NEW BERN TRANSIT STATION AREA PLAN
Proposed Revisions to January 15, 2008 Draft Document
February 14, 2008

New Bern Transit Station Area Plan

Revised Map 2: Concept Plan

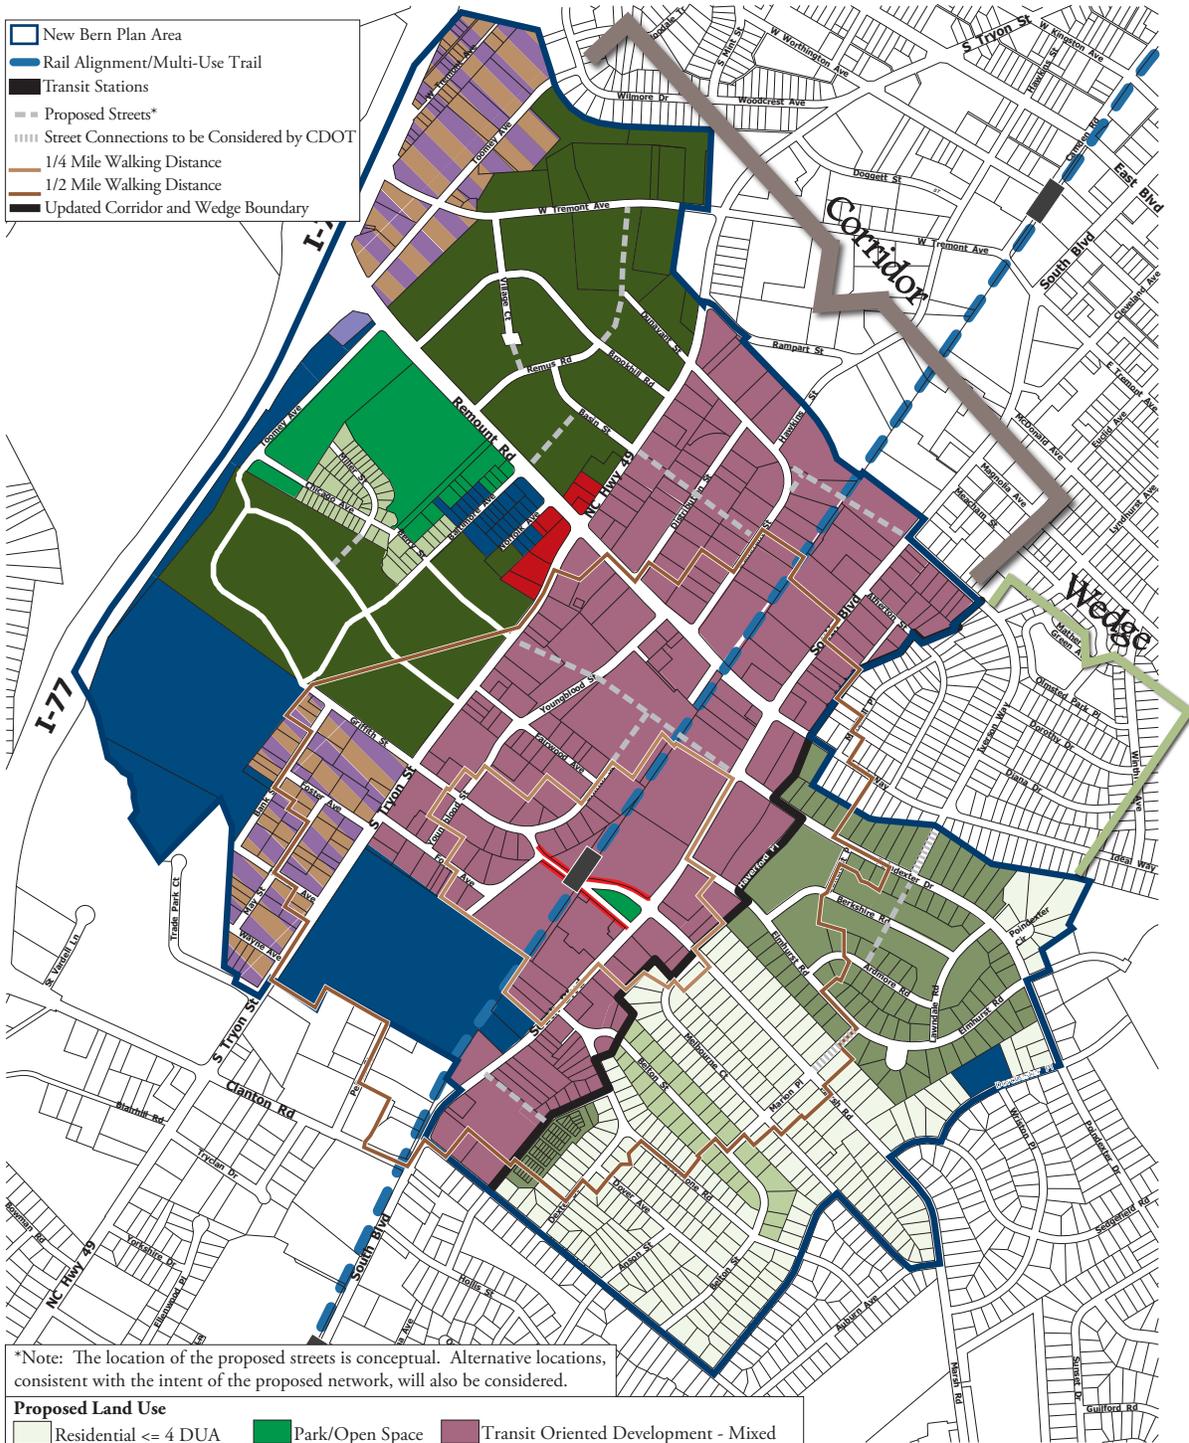
Page 7: Map 2, Concept Map

Substitute attached map.

Citizen Comment	Staff Response	Staff Recommended Revision
10. Keep single-family neighborhood around Miller Street and Chicago Avenue.	Staff agrees and this was noted in the Plan.	Plan text (item 12 on page 11) and Map 3, the Recommended Land Use Map, call for maintaining the existing predominantly single family housing along Miller Street and Chicago Avenue. Change to Map 2, the Concept Plan, will make this clearer.

Revised Map 3: Recommended Future Land Use

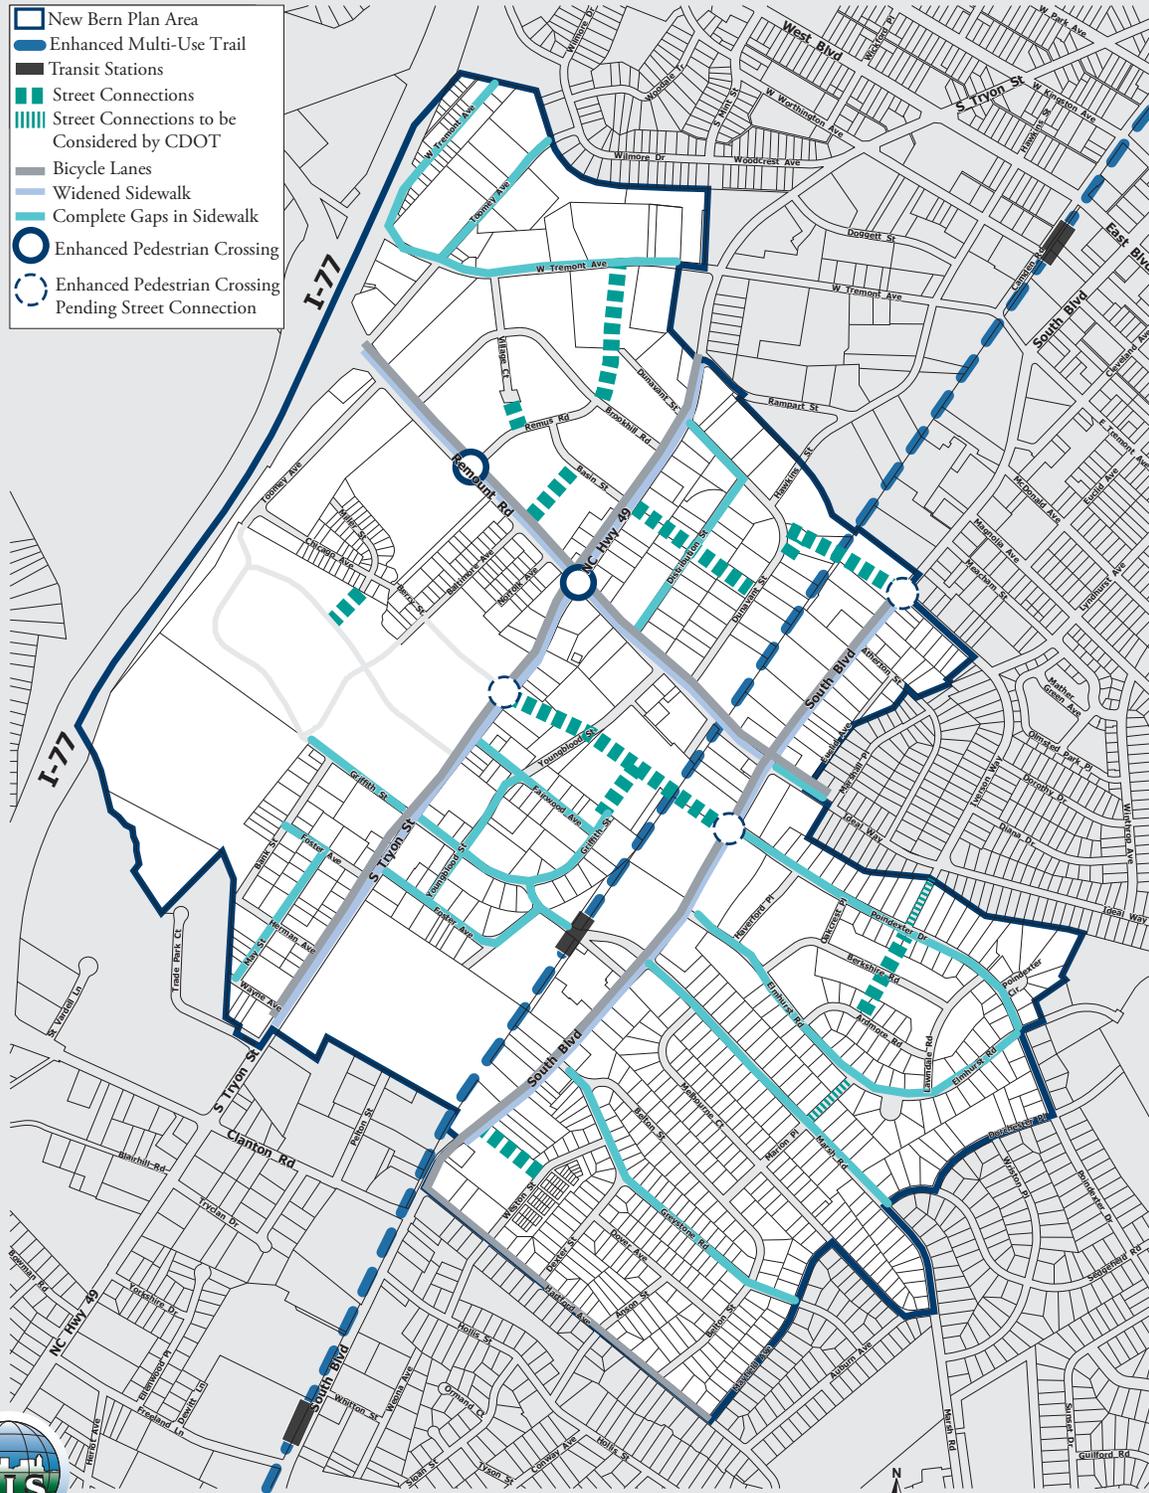
Page 8: Map 3, Recommended Future Land Use

Substitute attached map; make same changes to the extract maps on pages 9, 11, and 12.

*Note: The location of the proposed streets is conceptual. Alternative locations, consistent with the intent of the proposed network, will also be considered.
